February 5, 2024  
IDEA Weslaco Mechanical Upgrades

## **ADDENDUM NO. 2**

IDEA WESLACO  
 01 MECHANICAL & ELECTRICAL DEMOLITION PLAN (SERVICE YARD)  
 SCALE : 1/4" = 1'-0"

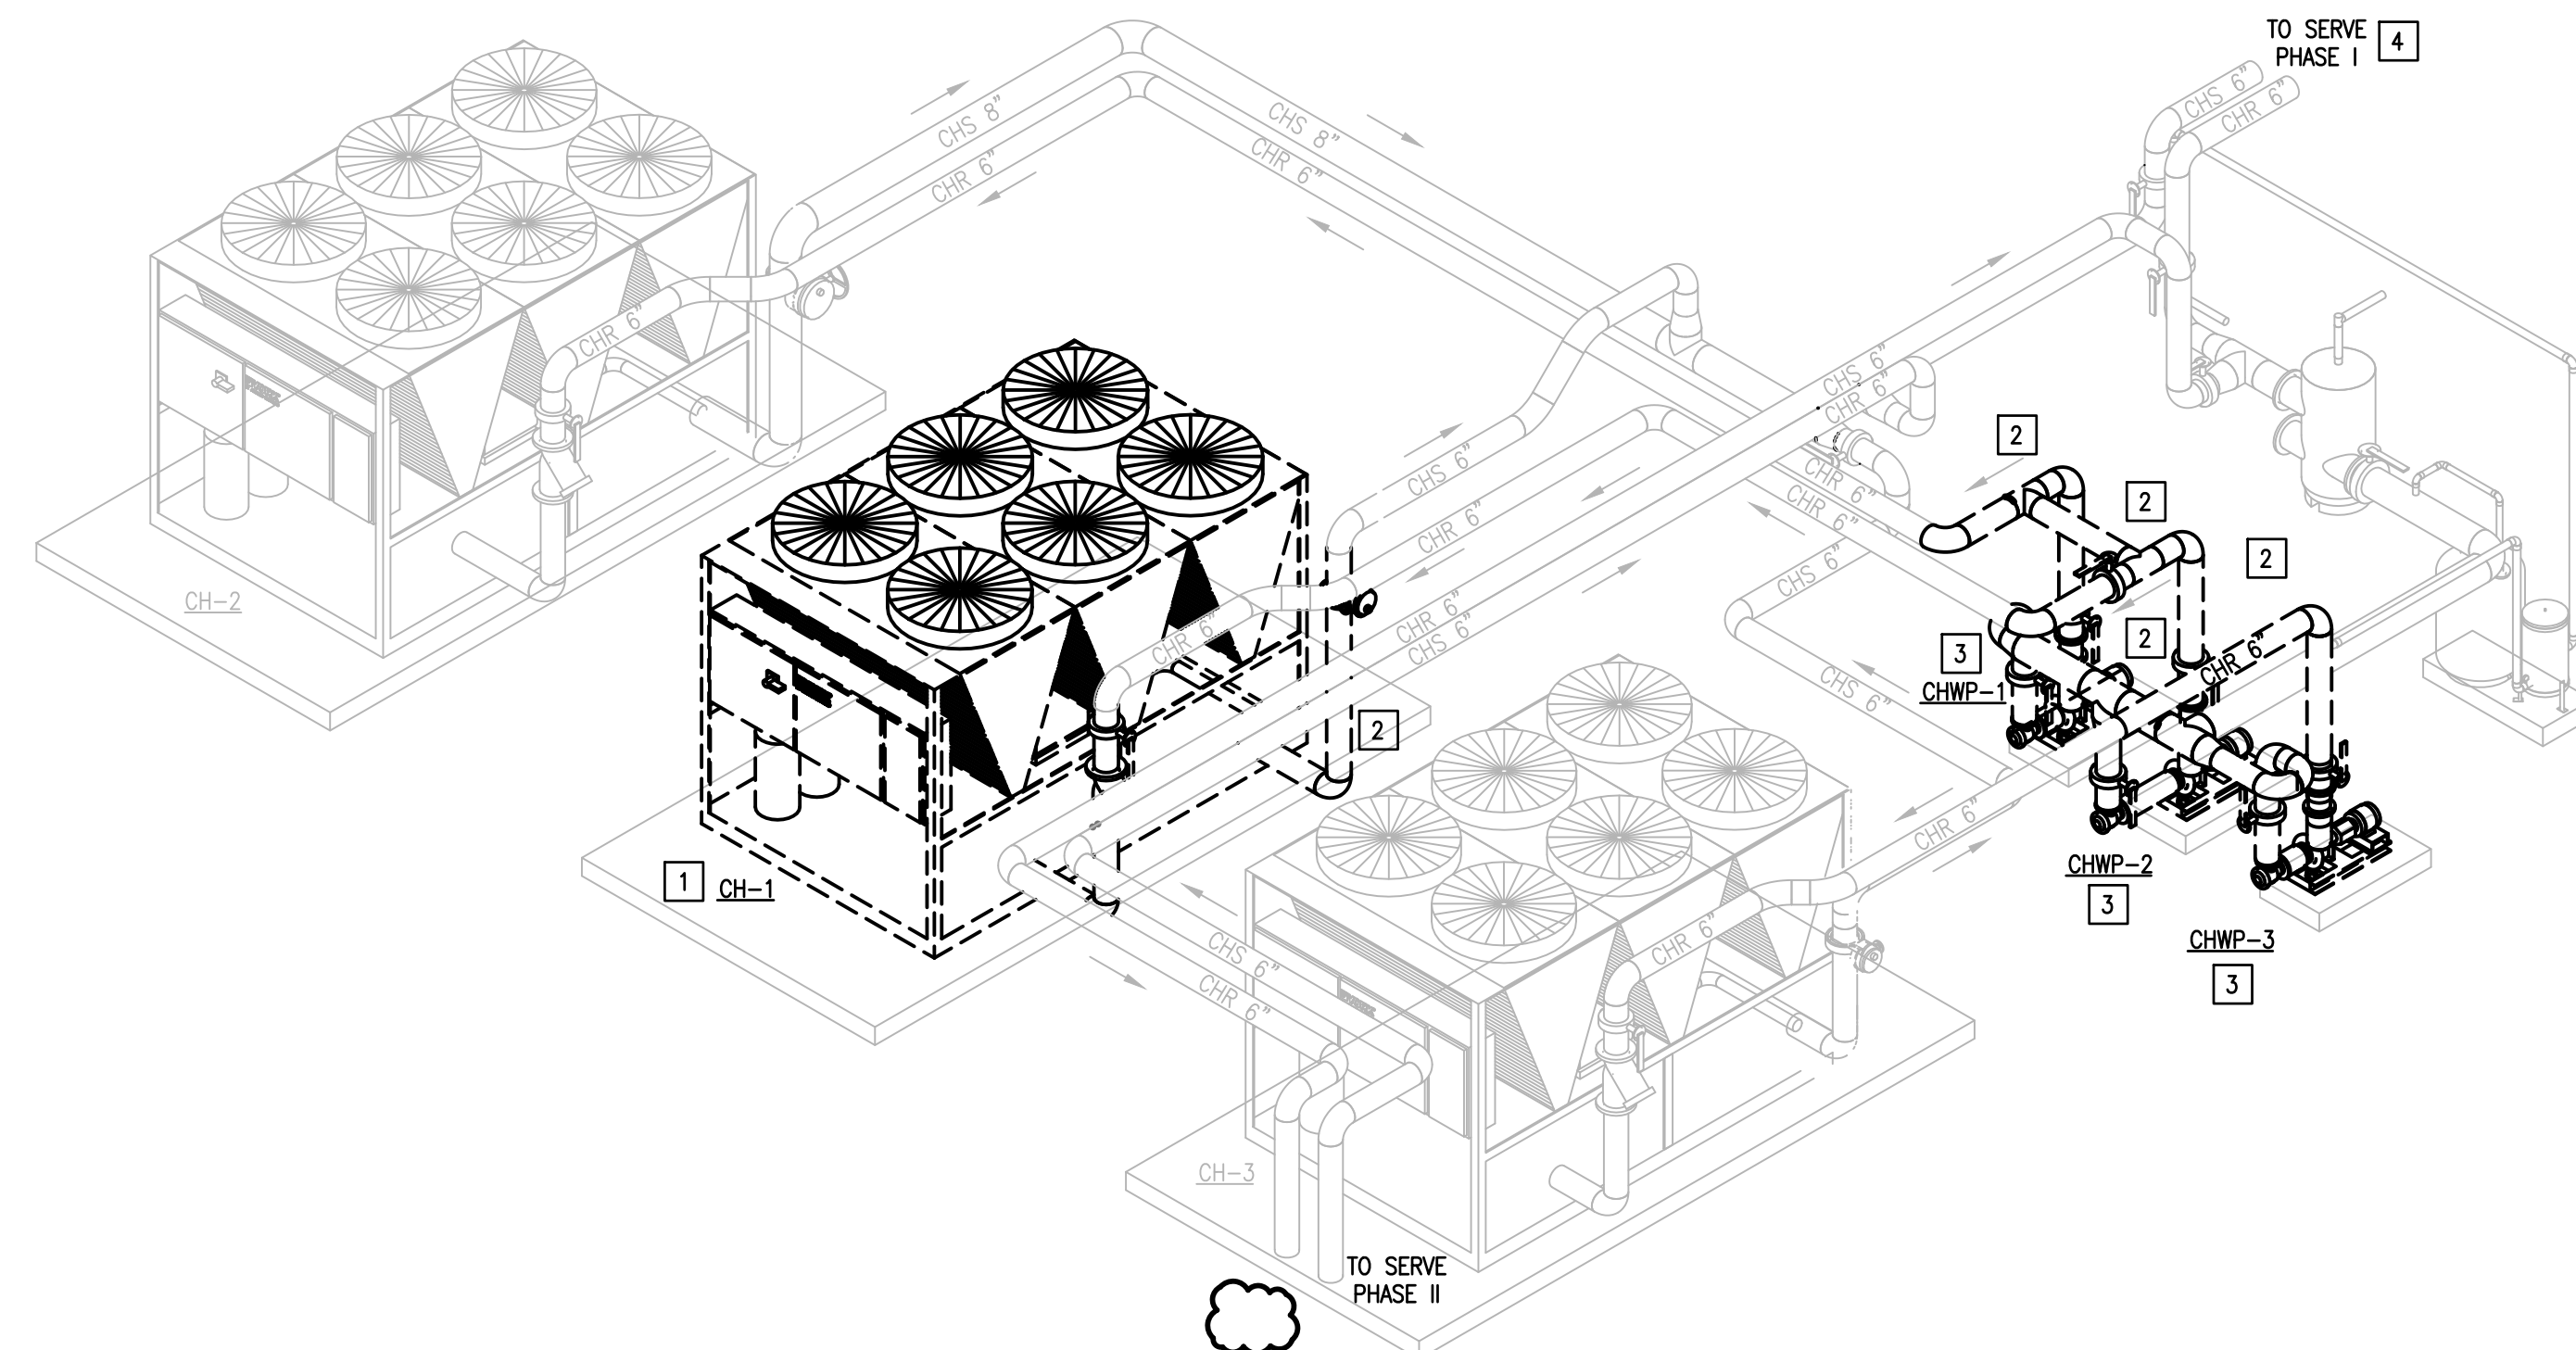
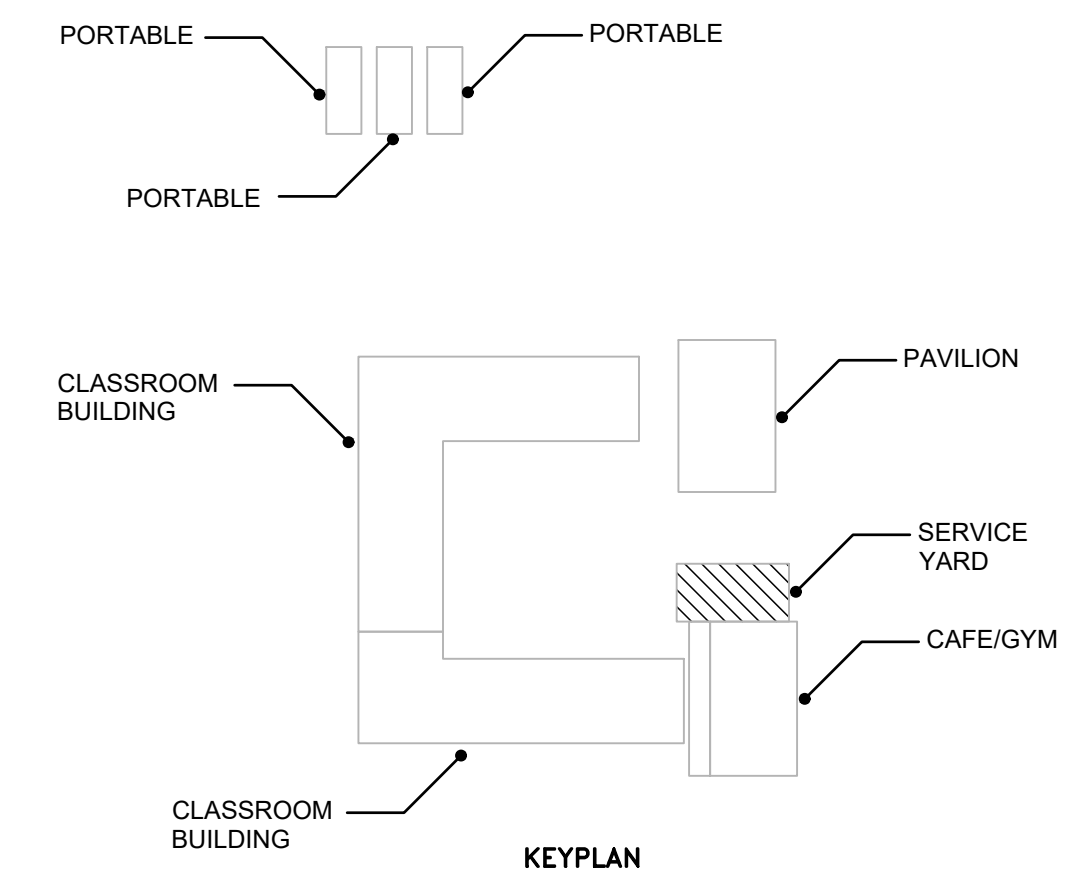
1. Sheet ME2.1:
  - a) Revised Mechanical & Electrical Demolition Plan. See attached sheet.
2. Sheet ME2.3:
  - a) Revised Mechanical & Electrical Renovation Plan. See attached sheet.
3. Sheet ME3.1:
  - a) Revised Mechanical & Electrical Renovation Plan. See attached sheet.
4. Sheet ME5.1:
  - a) Revised Equipment Connection Schedule. See attached sheet.
  - b) Revised equipment schedules. See attached sheet.
